September 25, 2025

**Subject: Lobo Crossing Traffic Impact Analysis  
Northeast of the I-25 and Gibson Blvd Interchange  
Albuquerque, New Mexico**

This letter is to inform you that the **FINAL** Traffic Impact Analysis (TIA) for the Lobo Crossing development on the north side of Gibson to the east of I-25 and Gibson interchange dated August 2025 has been reviewed. See Exhibit A for a conceptual site plan of this development.

### MASTER SITE PLAN

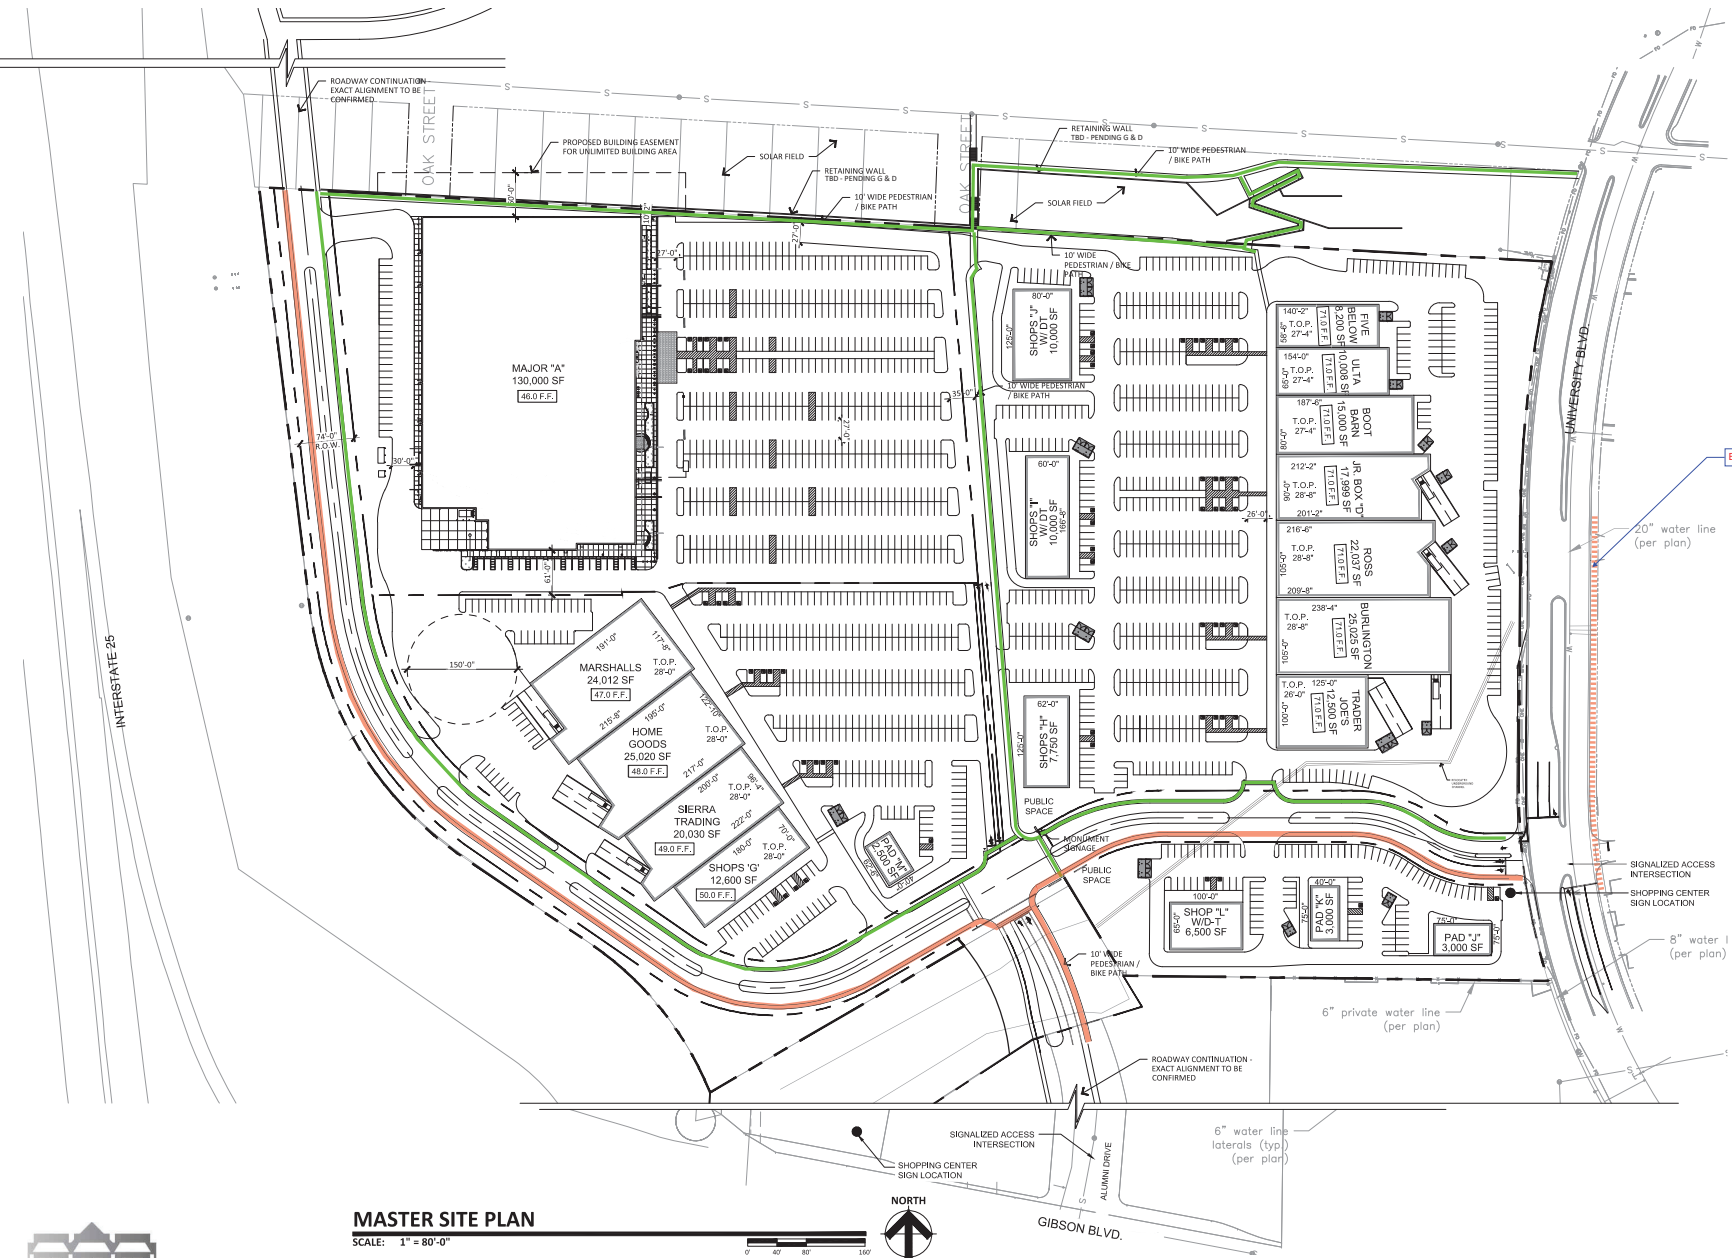
The NMDOT has no objection to using the existing full access at Alumni Ave and Gibson Blvd located about 500-feet from the I-25 and Gibson Blvd interchange northbound on-ramp. The recommendations provided for these analyses are shown in Exhibit B attached. Based on these analyses, the following conditions are required:

1. The development shall coordinate its signal design at Gibson Blvd and Alumni Ave with NMDOT. The final design concepts of the I-25 and Gibson Blvd interchange will take precedent over the design needs of the Gibson Blvd and Alumni Dr signal if such designs concepts were identified.
2. NMDOT does not support the installation of a signal at Avenida Cesar Chavez and Langham as proposed by this development. Coordination of the type of access and permanent intersection control of this intersection shall be coordinated with NMDOT, as it does not meet full access spacing requirements to the I-25 and Avenida Cesar Chavez interchange.
